## **2.2 Control and Instrument Systems**

The information in this section of the reference ABWR DCD, including all subsections, tables, and figures, is incorporated by reference with the following departures.

Figure 2.2.1 Rod Control and Information System Control Interface Diagram

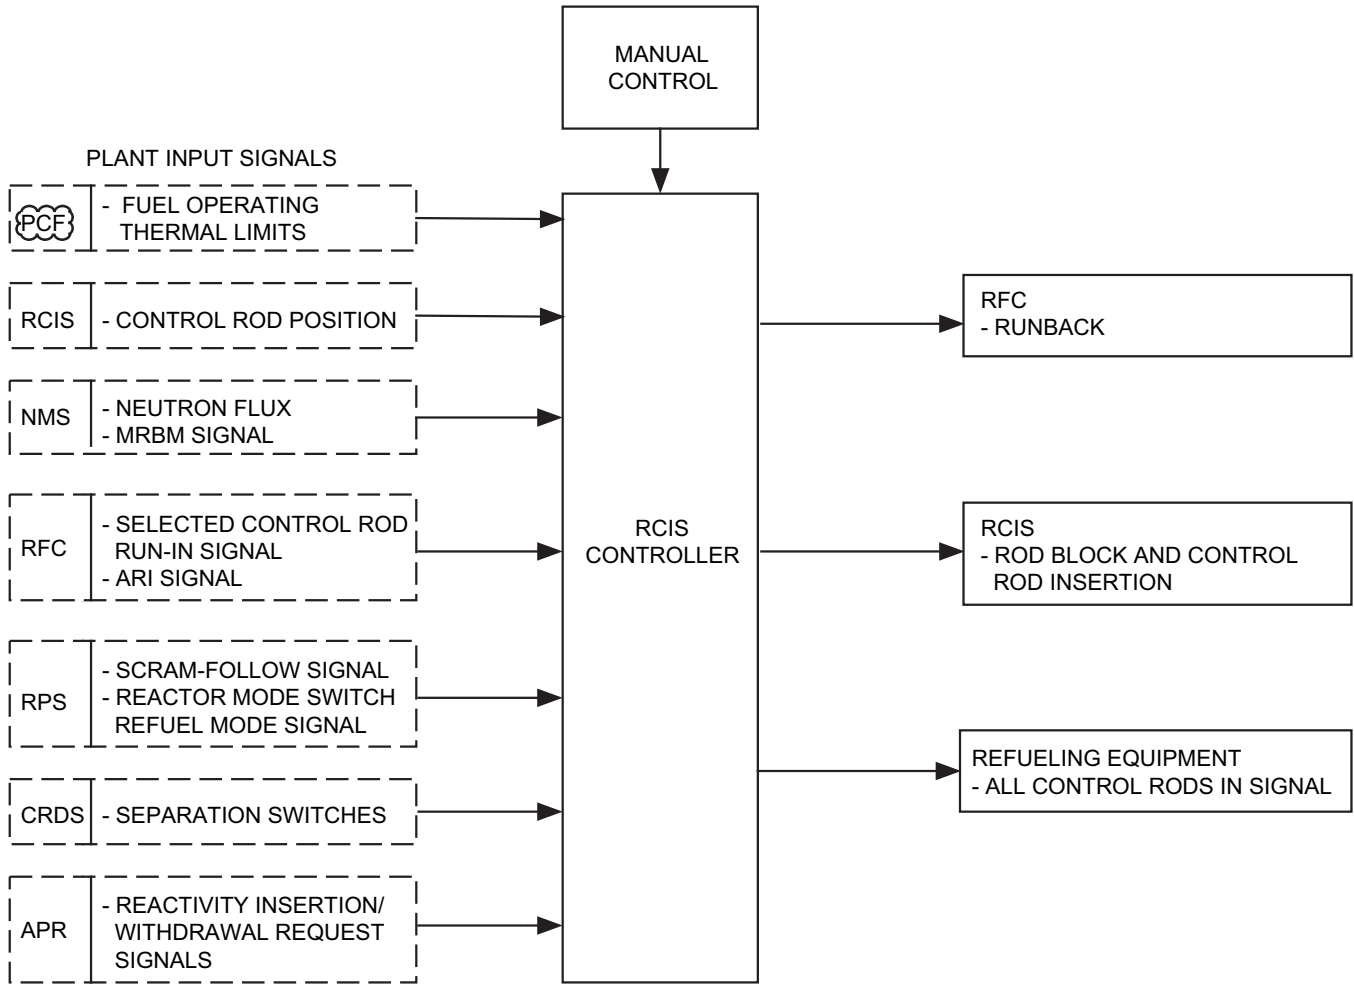
STD DEP T1 3.4-1 (Figure 2.2.1)

NOTE:  
1. INTERCONNECTIONS MAY BE FIBER-OPTIC OR METALLIC.

Figure 2.2.5 Neutron Monitoring System

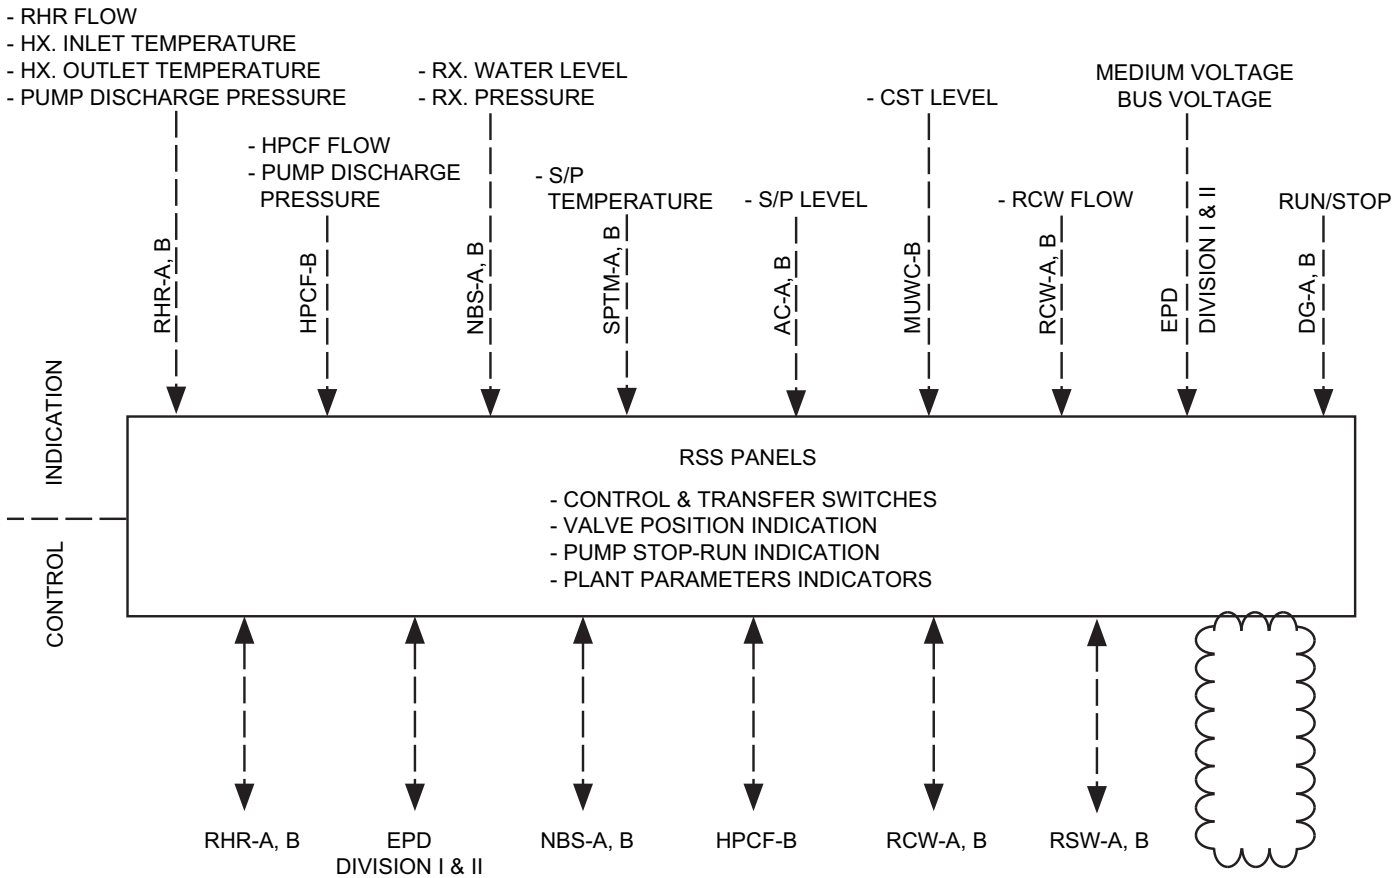
STD DEP T1 3.4-1 (Figure 2.2.5)

*The automated in-core instrument calibration system provides local power information at various core locations that correspond to LPRM locations. The automated in-core instrument calibration system uses its own set of in-core detectors for local power measurement and provides local power information for three-dimension core power determination and for the calibration of the LPRMs. The measured data are sent to the ~~Process Computer System~~ Plant Computer Functions for such calculation and LPRM calibration.*

1. DIAGRAM REPRESENTS ONE OF FOUR NMS DIVISIONS (MRBM IS A DUAL CHANNEL SYSTEM. THERE IS ONLY ONE IN-CORE INSTRUMENT CALIBRATION SYSTEM).
2. USED FOR RAPID CORE FLOW DECREASE TRIP.
3. SRNM AND APRM ATWS PERMISSIVE SIGNALS TO SSLC.
4. INTERCONNECTIONS MAY BE FIBER-OPTIC OR METALLIC.

Figure 2.2.7b Reactor Protection System

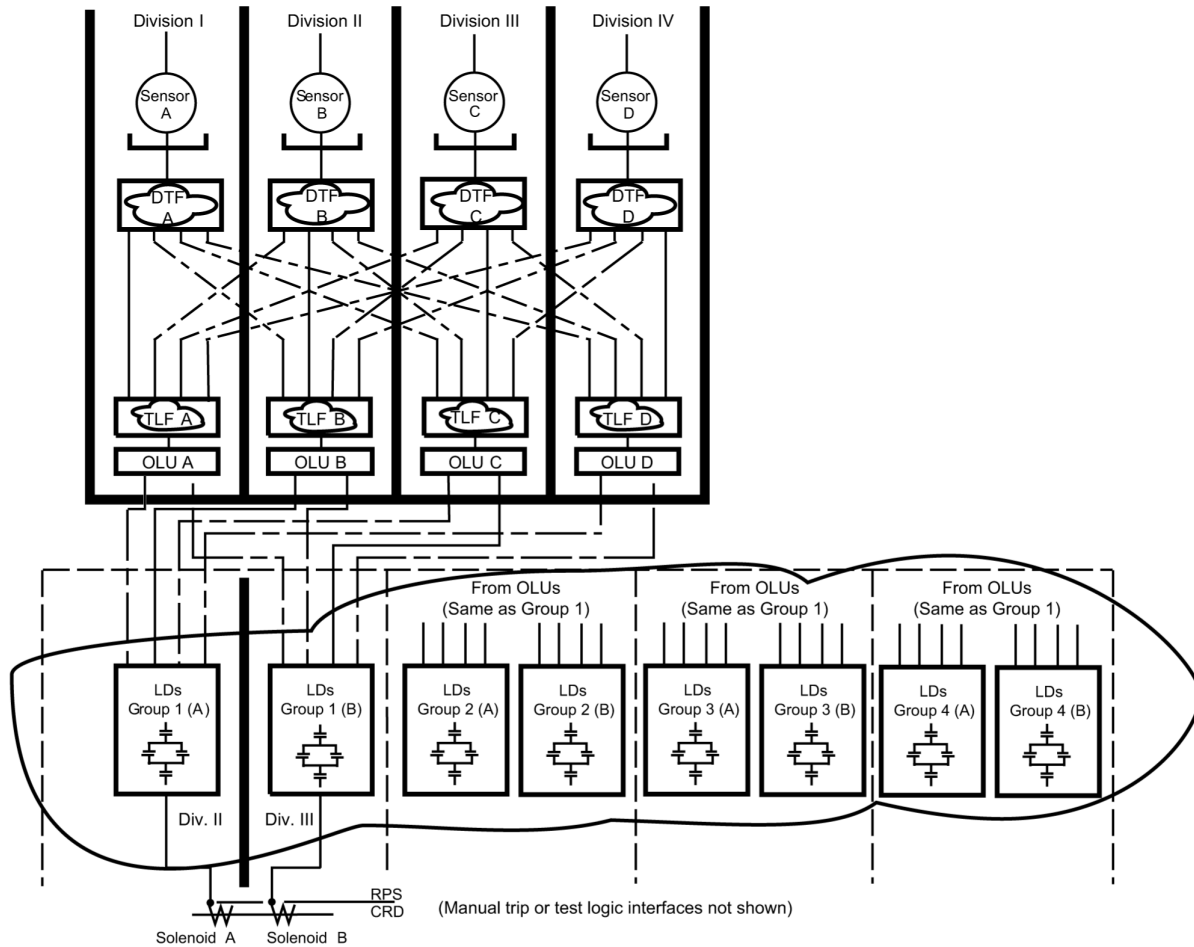
STD DEP T1 3.4-1 (Figure 2.2.7b)

The RPS has four divisions. Figure ~~2.2.6a~~ 2.2.7b shows the RPS divisional aspects and the signal flow paths from sensors to scram pilot valve solenoids. Functions Equipment within an RPS division consists of include sensors (transducers or switches), I/O, multiplexers, data communication, digital trip modules functions (DTM DTF), trip logic unit function (TLU TLF), output logic unit (OLU), and load drivers (LD). The LDs are only in Divisions II and III. The (DTF) and (TLF) are performed in digital configurable logic devices. The data communication functions are described in Section 2.7.5.

The RPS consists of logic and circuitry for initiation of both automatic and manual scrams. The automatic scram function is ~~comprised of~~ accomplished redundantly in four independent divisions of sensor instrument channels, hardware/software based logic and logic processing, and two independent divisions of actuating devices. Automatic scram is initiated whenever a scram condition is detected by two or more automatic divisions of RPS logic. ~~For automatic scram, the sensor input signals to the RPS originate either from the RPS's own sensors or other systems' sensors. For determination of the existence of an automatic scram condition, within each automatic scram channel division of the RPS, the DTM DTF of a given RPS channel division compares the monitored process variable with the a stored setpoint stored in its memory and issues a trip signal if the monitored process variable exceeds the setpoint. The DTM DTF then sends the trip signal to the TLU TLF of its own channel division and the TLU TLFs of the other three channels divisions of RPS, where two out of four voting is performed (see Figure 2.2.6a). The TLF in each division performs an independent two-out-of-four vote on each RPS DTF input.~~

~~In the case of high suppression pool average temperature trip and inboard/outboard MSIV closure signals, the SPTM module of SSLC and NBS provide their divisional trip signals directly to the corresponding divisional RPS DTM. However, In the case of the NMS, the four channels divisions of the NMS each provide their trip signals to each RPS divisional TLU TLF. A list of conditions that can cause automatic reactor scram is provided below. The name of the system that provides the sensor input signal or the trip signal is shown in brackets.~~

- (3) NMS Trips [~~Discrete trip signals to RPS TLUs~~ NMS]

- (7) Main Steamline Isolation [~~NBS discrete signals to RPS DTMs~~]
- (9) High Suppression Pool Average Temperature [~~SPTM Module of SSLC trip signals to RPS DTMs~~]

The ~~TLU~~ TLEs provide their trip signals to their divisional OLUs which ~~are used to~~ control the solid-state LDs that control the Class 1E AC power to the scram solenoids, and relays that control DC power to back-up scram valves. For automatic scram initiation, the ~~TLU~~ TLE trip signals cause the LDs to interrupt Class 1E AC power to the scram solenoids (fail-safe logic), cause the back-up scram relays to supply DC power to back-up scram solenoids, and provide scram follow signals to the RCIS. Each division of RPS controls eight LDs. The LDs are arranged to switch AC power to the scram solenoids in a two-out-of-four ~~format arrangement~~. That is, reactor scram will occur only if two or more divisions of the RPS provide trip signals to their associated LDs and both scram solenoids are de-energized.
